AGENDA  
PLAN COMMISSION  
Board Room, 3rd Floor  
Arlington Heights Village Hall, 33 S. Arlington Heights Rd.  
Arlington Heights IL 60005  
April 23, 2025  
7:30 PM

- I. CALL TO ORDER
- II. ROLL CALL OF MEMBERS
- III. APPROVAL OF MINUTES
  - A. PC Minutes 4/9/25
- IV. PUBLIC HEARINGS
  - A. PC24-025 - 660 N. Ridge Ave - Arlington Ridge Center Building Addition.  
PUD Amendment & Special Use Permit Amendment to expand previously approved  
PUD & Special Use Permit, Variations
  - B. PC25-007 - 500 E. Miner St. - Recreation Park Phase II & III  
PUD Amendment & Special Use Permit for Phase II & III of Recreation Park,  
Variations
- V. OTHER BUSINESS
- VI. PUBLIC COMMENT

**Plan Commission  
4/23/2025**

**To:** Plan Commission  
**Prepared By:** Dan Osoba, Planner I  
**Meeting Date:** April 23, 2025  
**Date Prepared:** April 11, 2025

## PROPOSED FLOOR PLANS COMMUNITY BUILDING

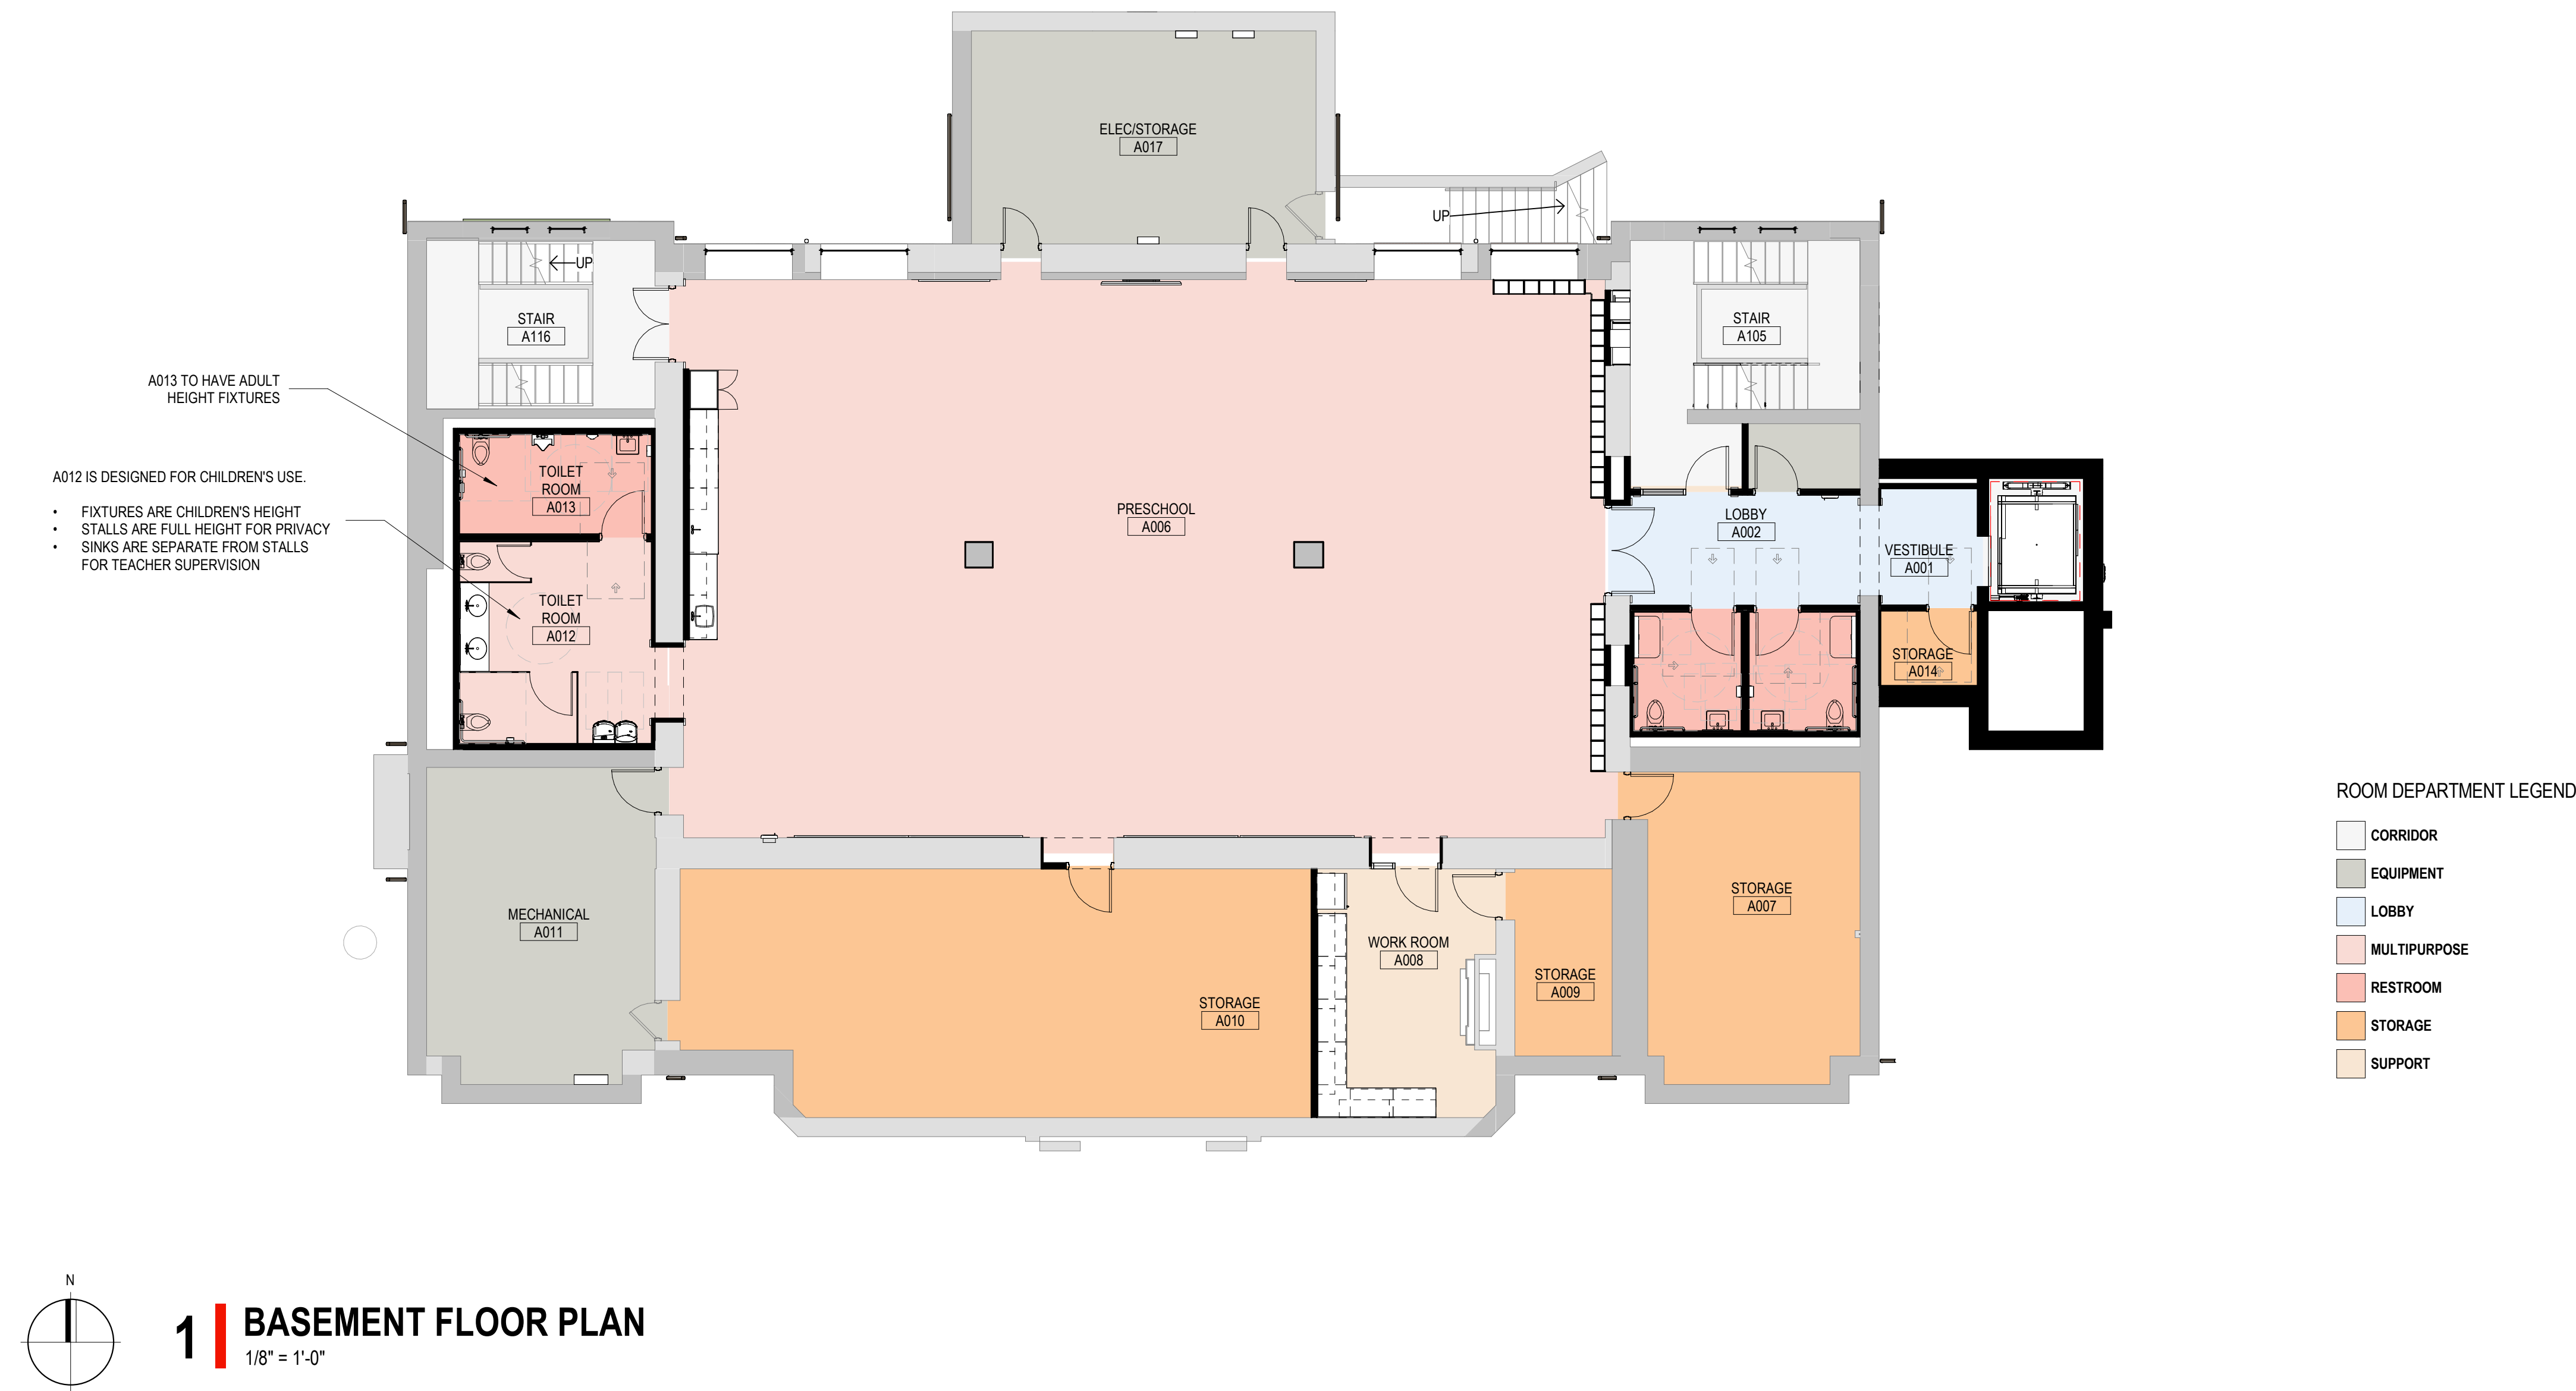
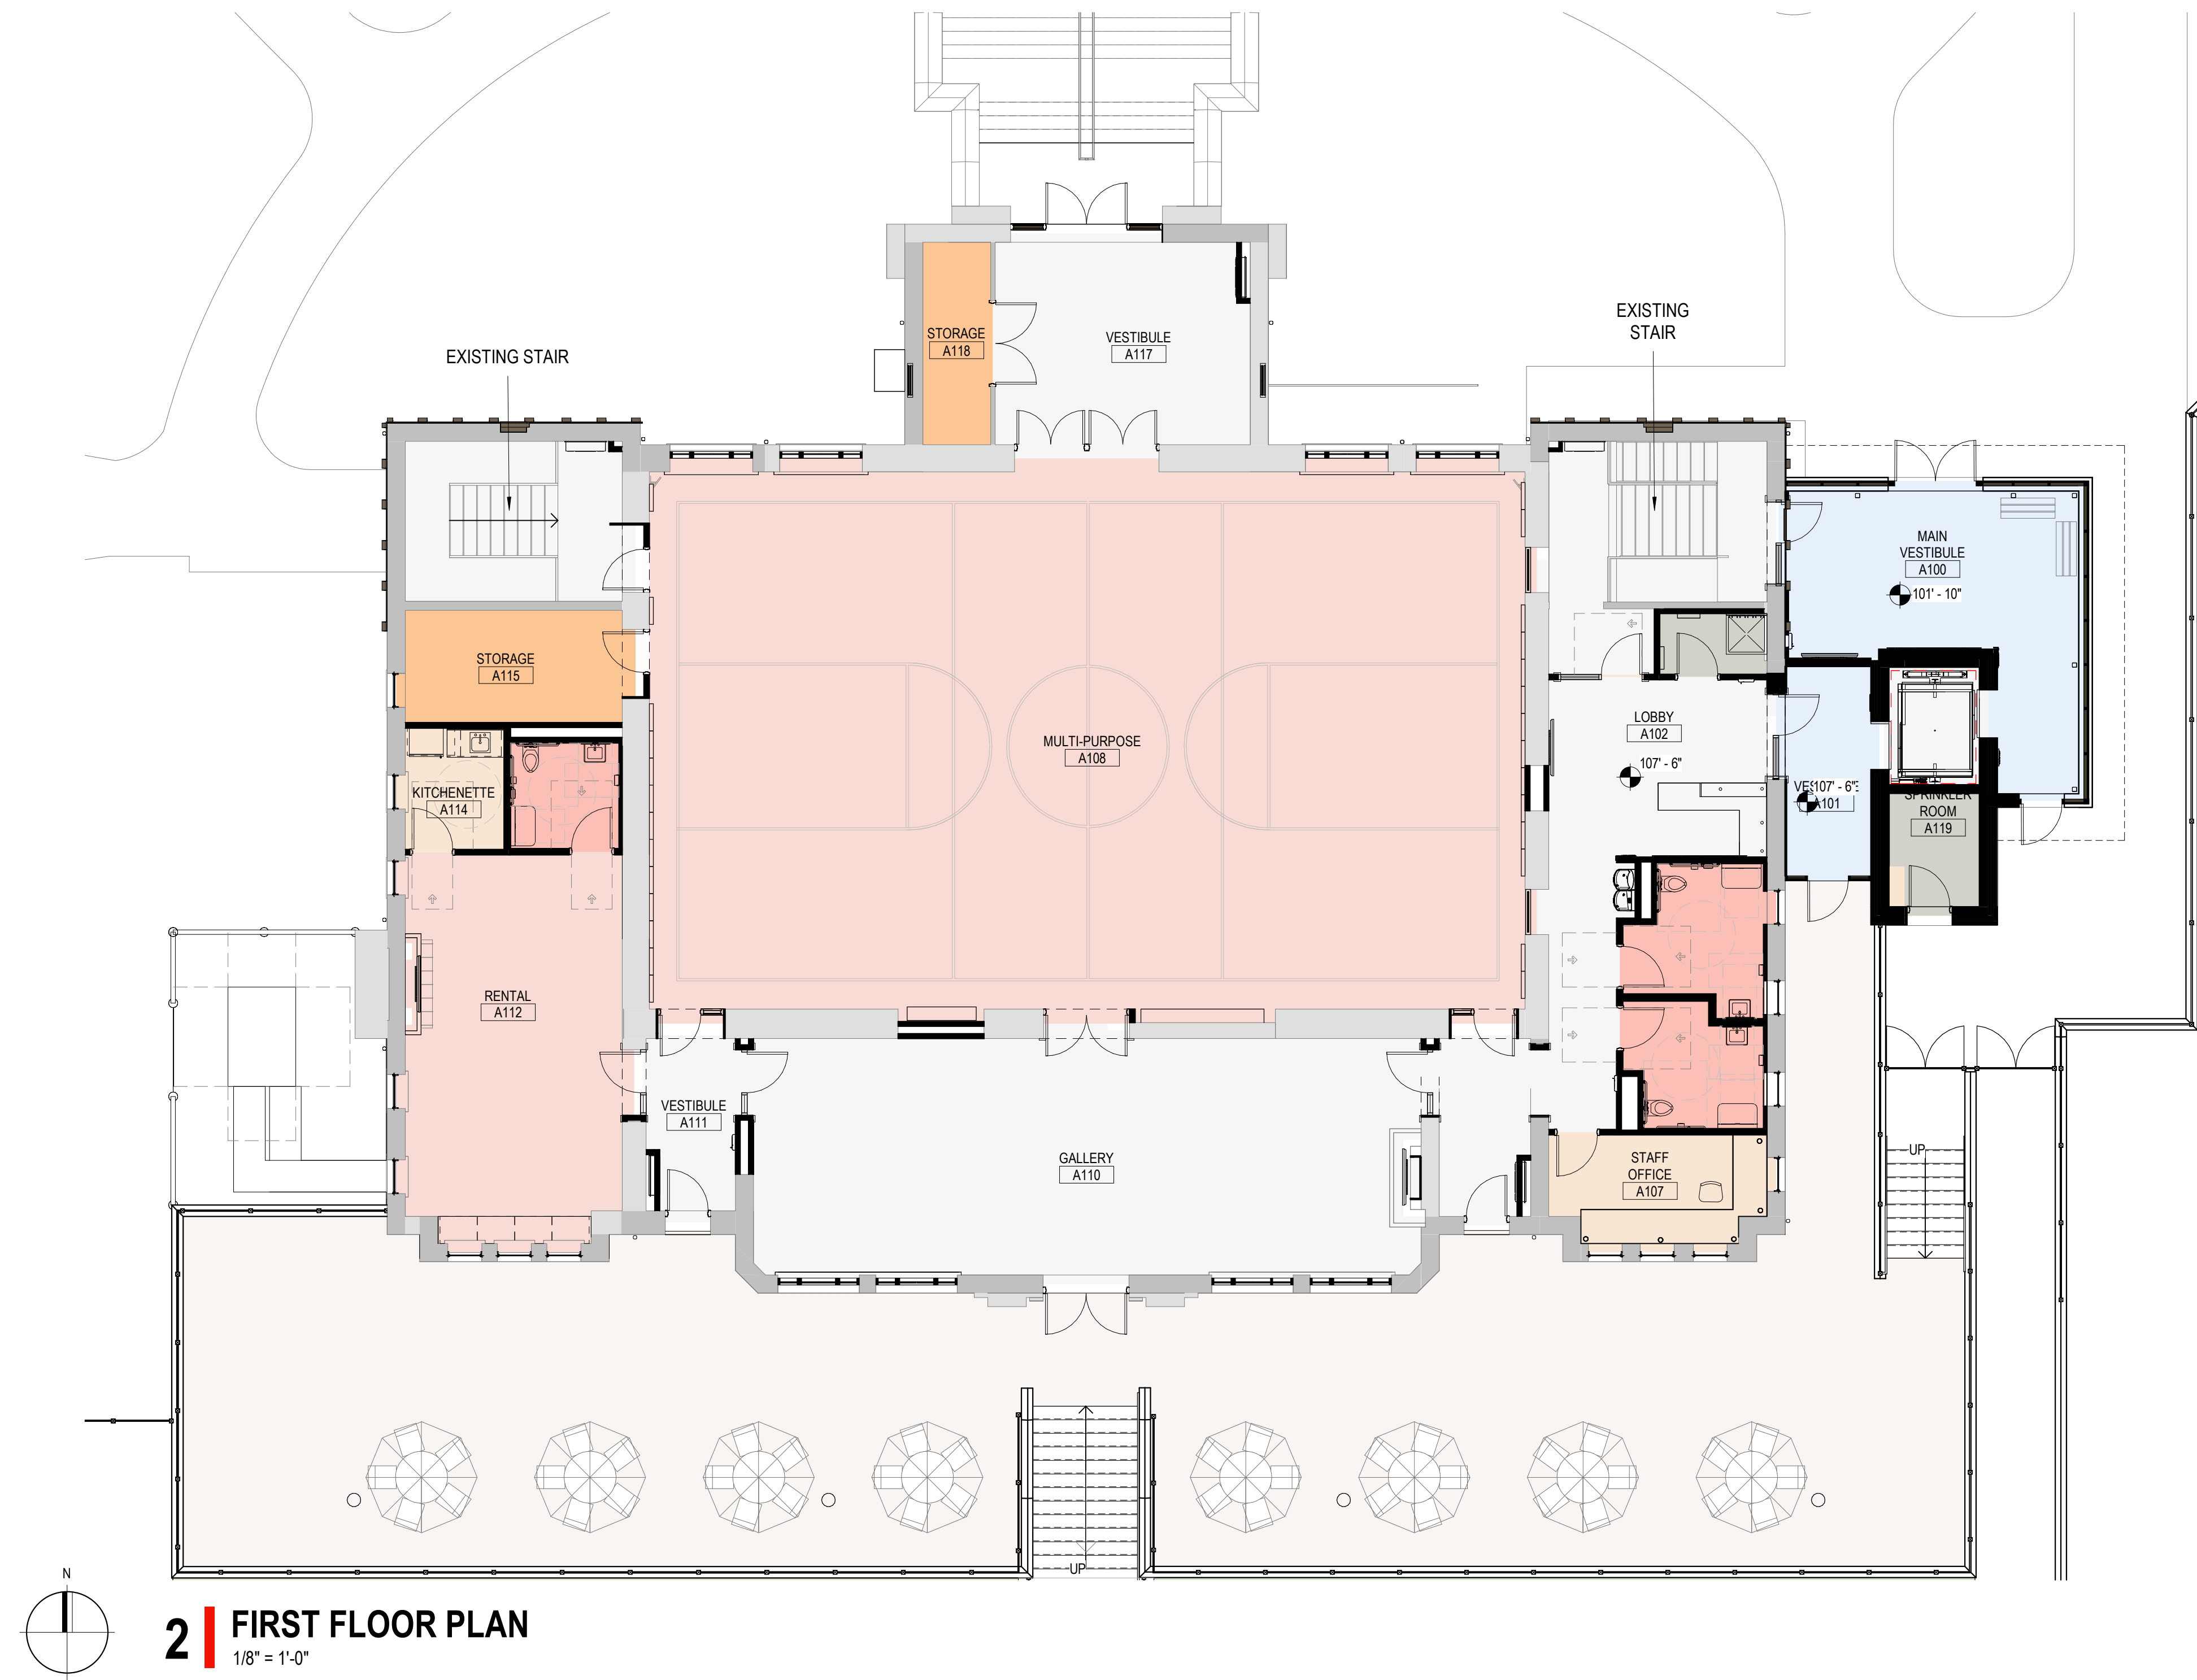
2. For the PRESCHOOL area in the basement, please clarify the division of space between toilet areas A012 and A013.  
**Response: A012 is designed for children's use. Fixtures are children's height, stalls are full height for privacy, and the sinks are separate from stalls for teacher supervision. A note has been added to sheet A2.**
